***Council Decision on  
Proposed District  
Plan Change 46***

**Subdivision Design Guide Review**

### REPORT OF THE DISTRICT PLAN HEARINGS COMMITTEE

**SUBJECT:** **PROPOSED DISTRICT PLAN CHANGE  
46: SUBDIVISION DESIGN GUIDE  
REVIEW**

- G4.2 Minimise disturbance to natural landform.

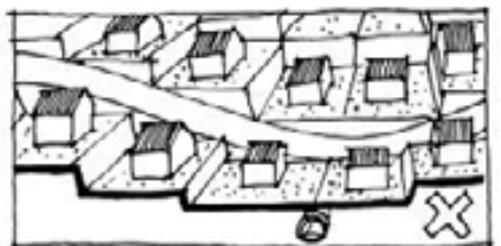
provision G4.2 but particularly the last sentence in the italicised explanatory statement that reads:

*“Some contour modifications on hillsides is expected to provide access and for the building footprint, but stepping and terracing of lots should be avoided.”*

Truebridge Callendar Beach Ltd appeared at the hearing and spoke to their submission. They also spoke on behalf of Lincolnshire Farm Ltd and Woodridge Estate Ltd. Detailed evidence was presented as to why the submitters disagreed with limitations on the stepping or terracing of lots and the reasons why this method of site development was believed to be desirable. The submitters disagreed that stepping and terracing should be avoided, arguing that it “is a temporary change to the landform that allows for the easy construction of buildings with maximum outdoor usage and the easy maintenance of lots.”

It was acknowledged that over time the visual effects of terracing would be mitigated to an extent by the placement of buildings, landscaping and planting but the Committee still felt strongly that the long-term streetscape effect of repetitive terracing would not be fully ameliorated. A generally poor streetscape quality would remain.

While not supporting the deletion of the guideline relating to terracing the Committee did consider that Provision G4.2 could be expanded to more fully explain the circumstances for acceptable contour modification for the creation of building lots.

*“but wholesale stepping and terracing of lots should be avoided. Where contour modification occurs, the slopes, edge alignments and contour transitions created should relate to existing contours and reflect natural landform. Any transitions at lot edges should be battered, with a slope that harmonises with the natural contours.”*

That the submission from Ohiro Properties Limited be accepted to the extent that at the end of provision G4.2 the following sentence be added:

*“Where landform modifications are made, cut faces should be concealed behind development, or finished to present as natural an appearance as practicable.”*
